SUBMISSION

NorthConnex SSI 13_6136

Community Against
Polluting Stacks

Figure 1: Portal placement. NorthConnex proposed portal ★ CAPS proposed portal ★

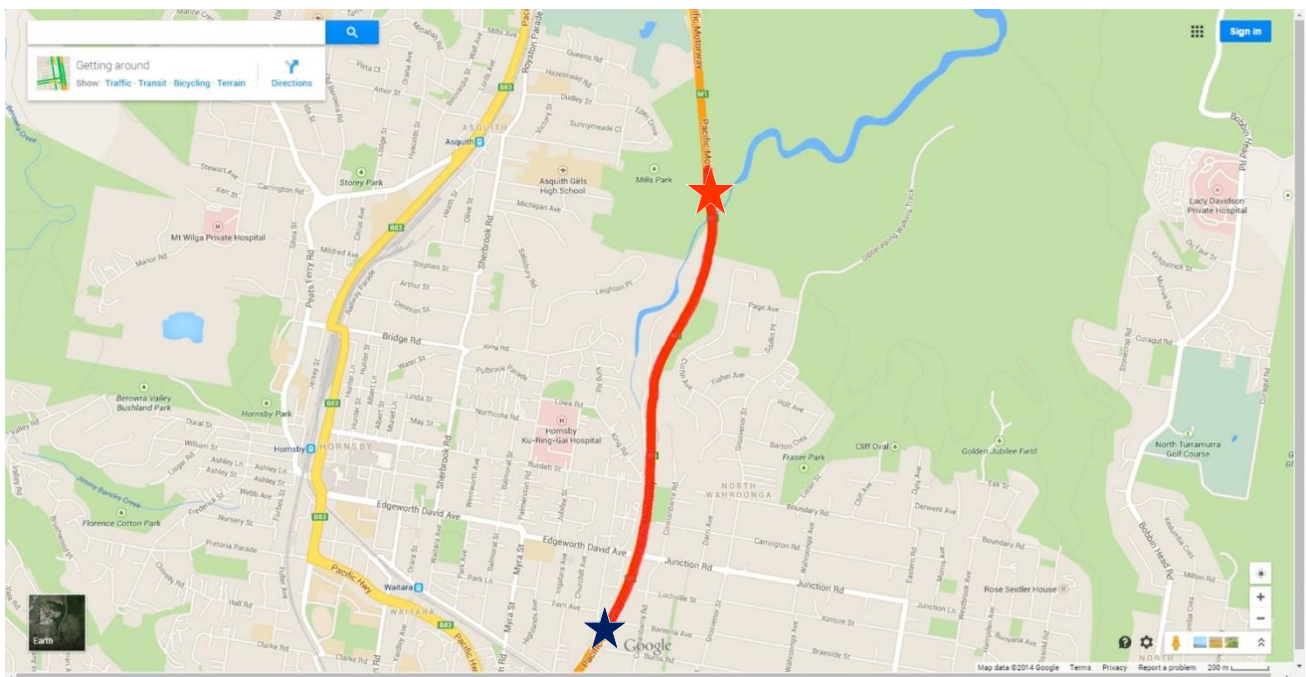
Also in placing exit portals away from residential areas there will be other massive benefits for the community including:

- Significant reduction in construction impacts including reduced noise, vibration, dust, amenity, traffic and visual impacts.
- Reduction in private property acquisitions.
- No loss in private property values.
- Reduction in visual impacts from surface infrastructure.

Figure 2: Portal located near Pearce's Corner

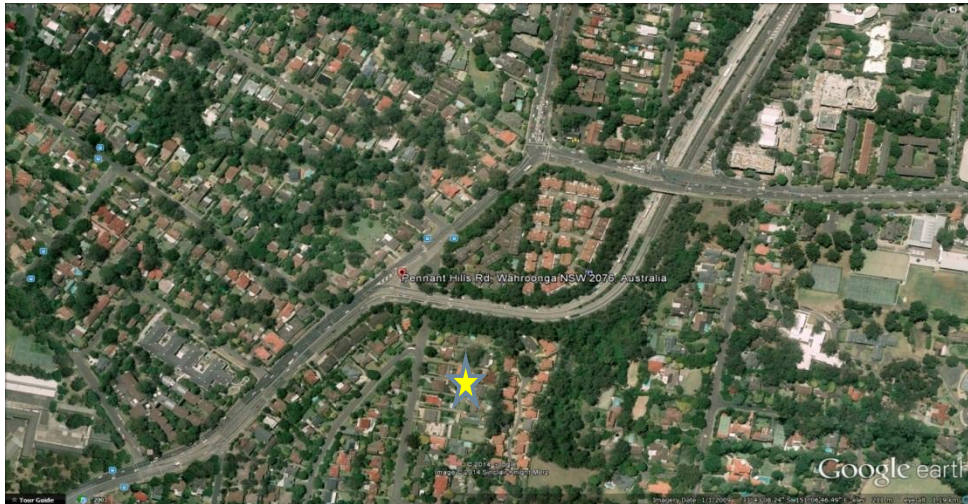
For the Pacific Highway/Pennant Hills exit portal located near Pearce's Corner - there are no feasible options to move the portal to an area of lower population density. At this portal, there will be an 800-850m long off ramp with no associated stack, and where jet fans will be expected to overcome the piston effect, despite there being no jet fans for the final 300m of tunnel. The alternative options for this location include:

- Revised ventilation design to ensure that there are no portal emissions – and a commitment from NorthConnex that there will be no future emissions from this portal.
- Installation and operation of inline tunnel filtration system. This system would not be large as the Pacific Highway/Pennant Hills off ramp is relatively short and only one lane wide – and could easily be installed on RMS land at the Pearce's Corner construction compound.
- RMS could offer to purchase properties within a 200m radius (at unaffected market value, plus costs eg stamp duty, removalist fees, etc).

Figure 3: Position of CAPS proposed portal ★, with exhaust stack ■ vented into Ku-Ring-Gai National Park

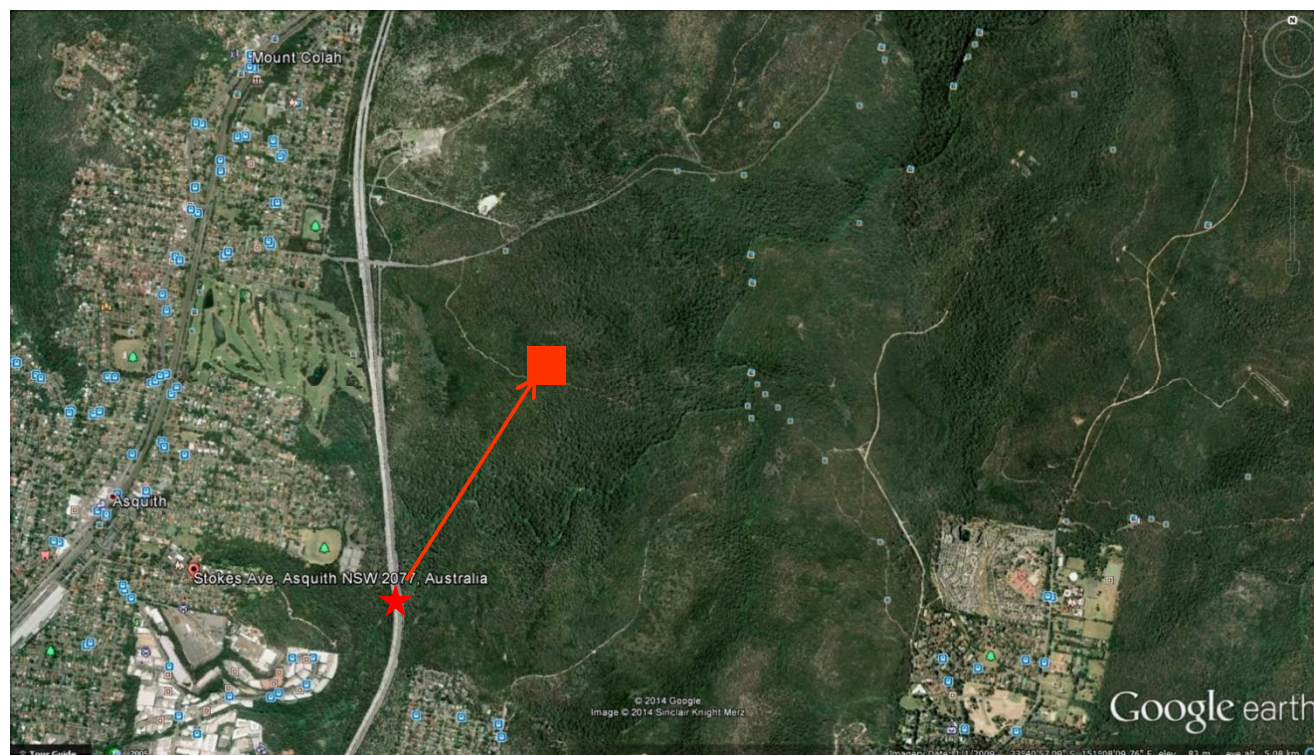
Whilst separating the portal and stack consumes more energy, it does not alter the effectiveness of the tunnel ventilation system. As the stack would be away from residential, this may also allow construction of stack and associated services to continue out of hours.

Moving the northern tunnel portals and stack away from residential areas is in keeping with the comment made by Steve Cornish (Program Manager, Transurban) that this would be "better for the community" (April 2014).

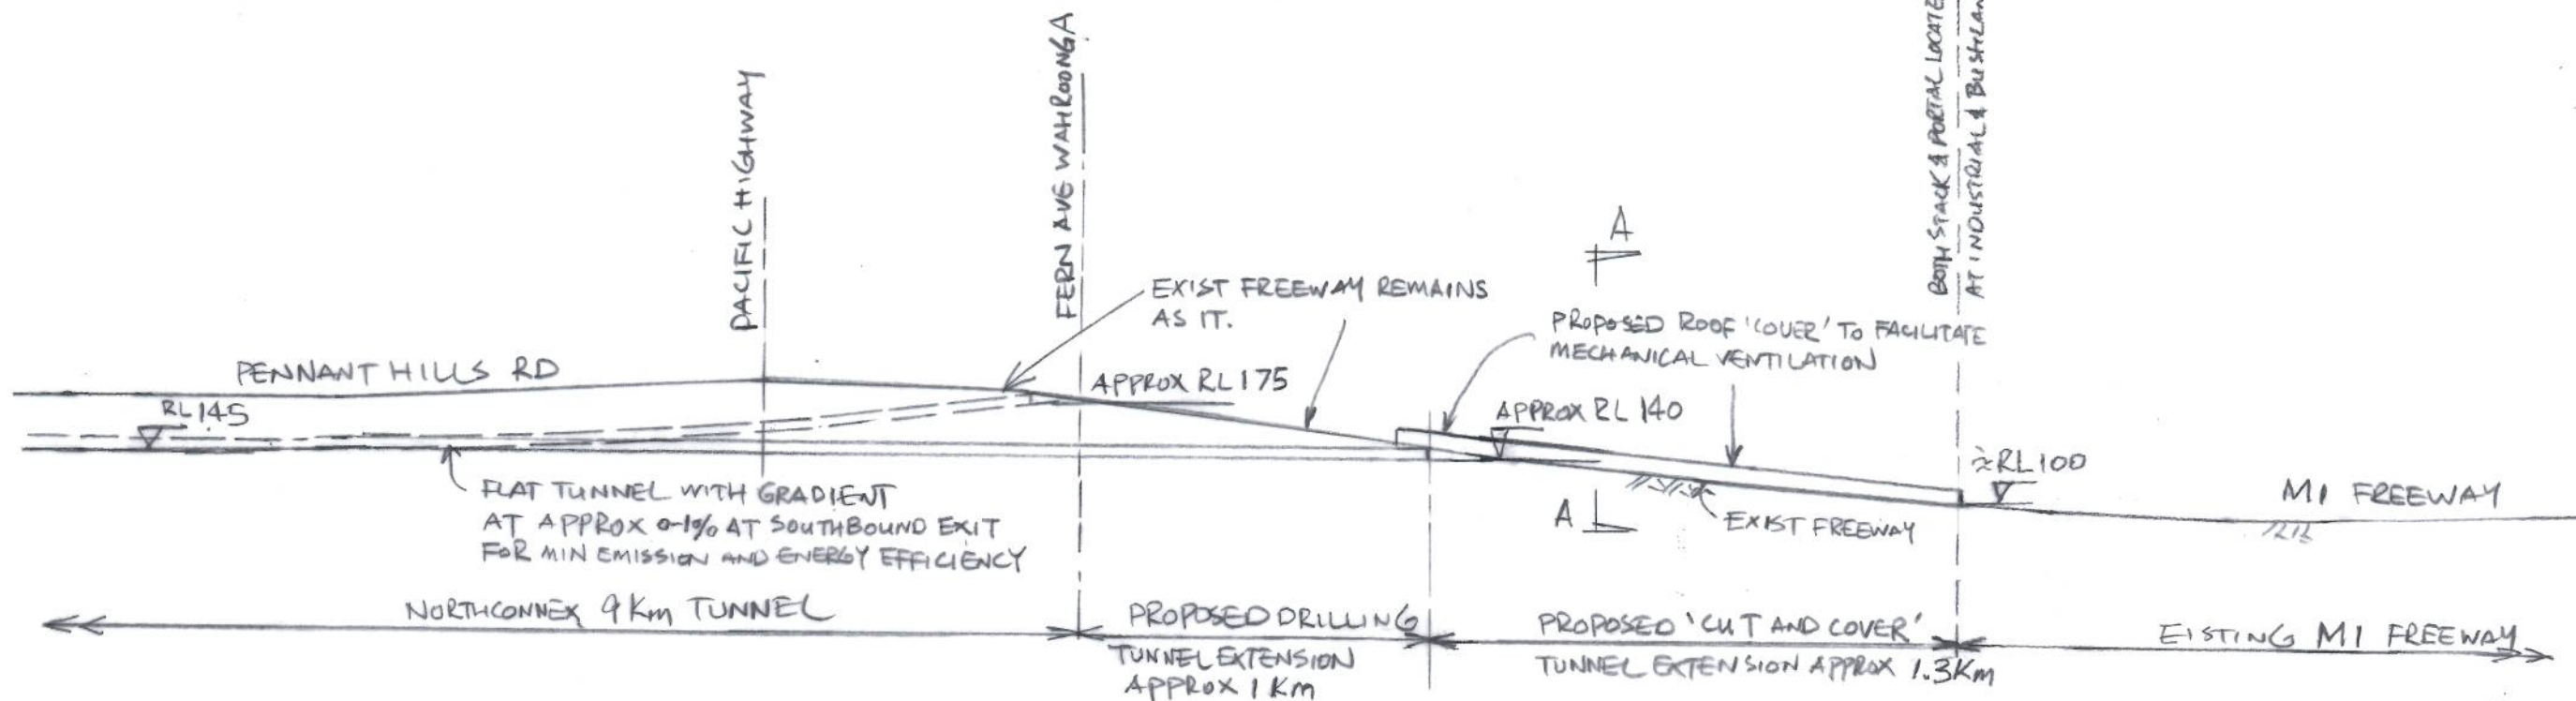
The geological long section of the tunnel presented in Appendix D of the EIS shows that the tunnel from the M2 portals (at about 123 metres RL) dips significantly below the proposed NWRL (to an RL of about 75m) before rising to about RL 175 at the M1 portals in Wahroonga. Because of this significant sag in the tunnel, both southbound and northbound vehicles experience high road grades – which result in the generation of significantly higher quantities of pollutants.

A much better solution would be to reduce the grade to as close to zero as possible. While this is not possible with the M1 portals being located in Wahroonga, however, if the portals were located on the M1 in line with Stokes Avenue in Asquith (which is about RL 121 metres), a zero grade tunnel at approximately 120 metres RL becomes a closer reality. The only issue is the interface with the NWRL and a low point just north of the M2. A more complex tunnel alignment and construction methodology would be required in this area (with NorthConnex going over the NWRL slot rather than under), however, there is no technical reason why this could be achieved. As the NWRL would not be an operational rail line (and NWRL tunneling may not have even reached this location by the time NorthConnex starts tunnel construction), the construction and safety risks are significantly reduced.

ALTERNATIVE 'CAPS' PROPOSAL FOR 'CUT & COVER'
TUNNEL EXTENSION AT WAHROONGA
AT 21/8/14

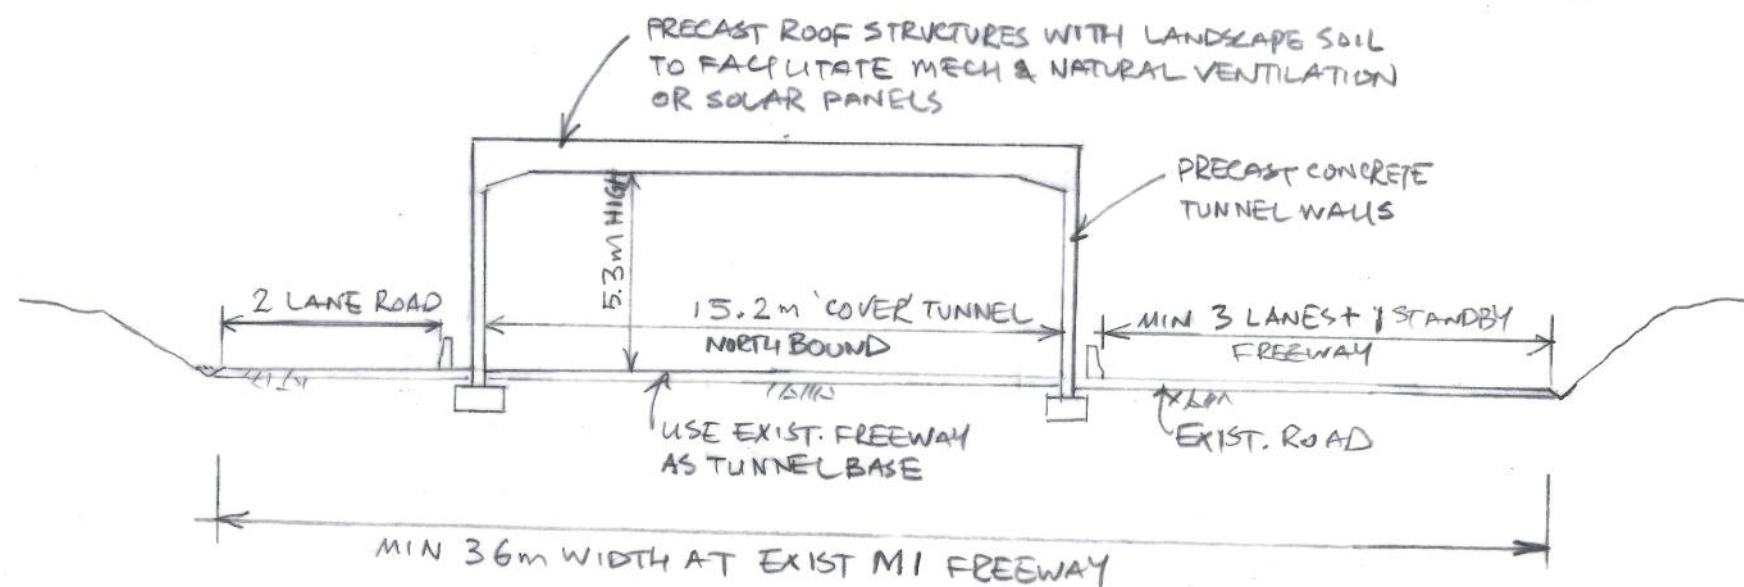
Another alternative to extend the tunnel further north would be to cover the existing M1 with a concrete structure. Basically once the tunnel reaches RL 140 metres instead of continuing to tunnel up to RL170 metres at Woonona Ave, a flat tunnel would be constructed which would exit about 1 kilometre north of the currently proposed M1 exit portal location. For another kilometre the tunnel could be extended using an above ground concrete tunnel. The cost of this type of construction would be significant lower than underground tunneling (about 75% lower) – and appropriate safety and egress requirements could be easily implemented. A diagram showing the concept is presented on the following page.
